Reference: 220450.04FA

LETTER OF RESPONSE OF MIXED USE DEVELOPMENT AT MORGAN STREET & MURRAY STREET, WAGGA WAGGA

PROJECT: **CIVITAS STAGE 3**
 Morgan, Murray & Forsyth St, Wagga

Scenario A: Traffic Assignment

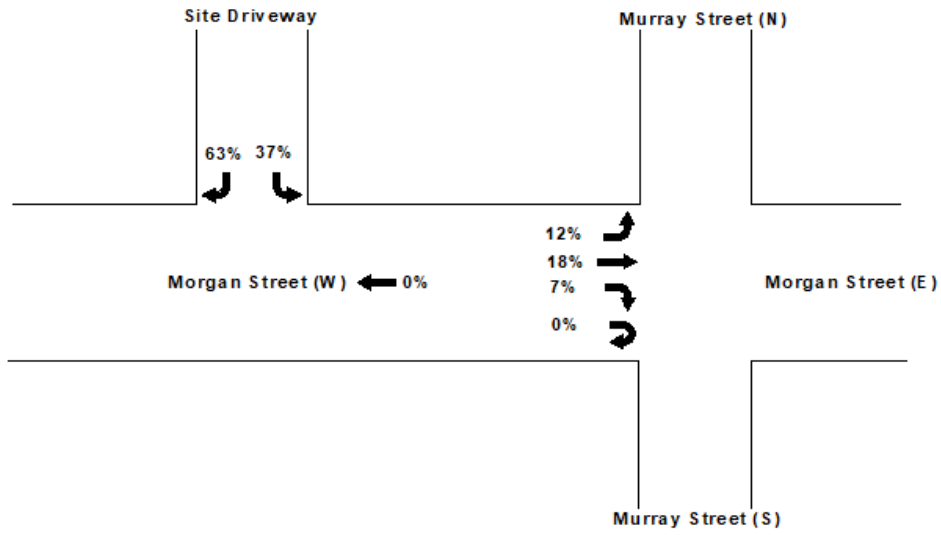
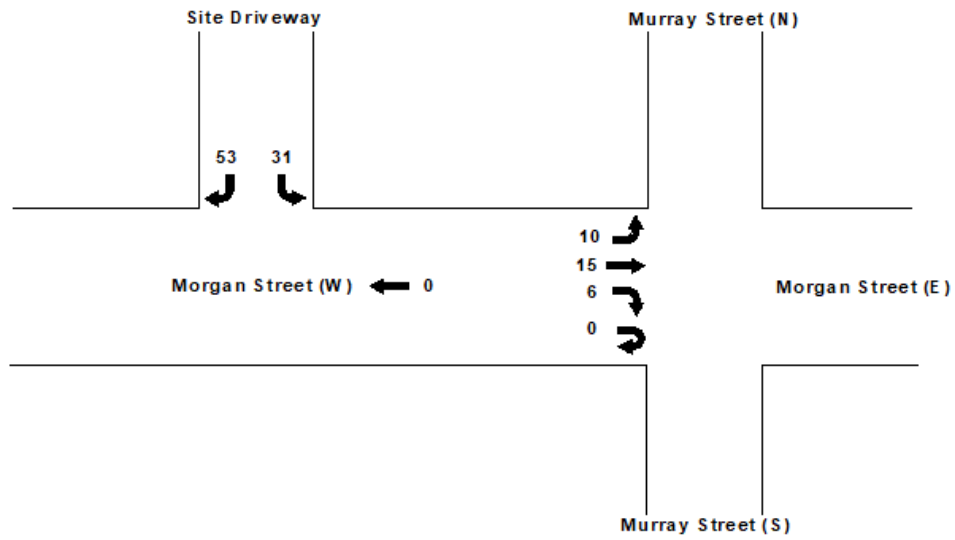
An assessment of the performance and safety of the intersection of the eastern service road egress and Morgan Street. This should include both left out only and left and right-out scenarios. The leftout scenario shall also model impacts on the roundabout at the intersection of Morgan and Murray Street.

- Scenario A: Vehicles are permitted to exit the service road egress on Morgan Street via both a left and right turn manoeuvre;
- Scenario B: Vehicles are only permitted to exit the service road on Morgan Street via a left turn manoeuvre. Vehicles who intended to turn right at the site driveway will instead complete a U-turn at the intersection of Morgan Street / Murray Street. All other vehicles will follow the same route completed in Scenario A;

Traffic distribution and subsequent traffic assignment for each scenario has been depicted diagrammatically in **Annexure B**, following the assumptions made in *MTE Report 220450.01FB – Section 4.5 Traffic Assignment – Figure 11: Trip Assignment – Masterplan*.
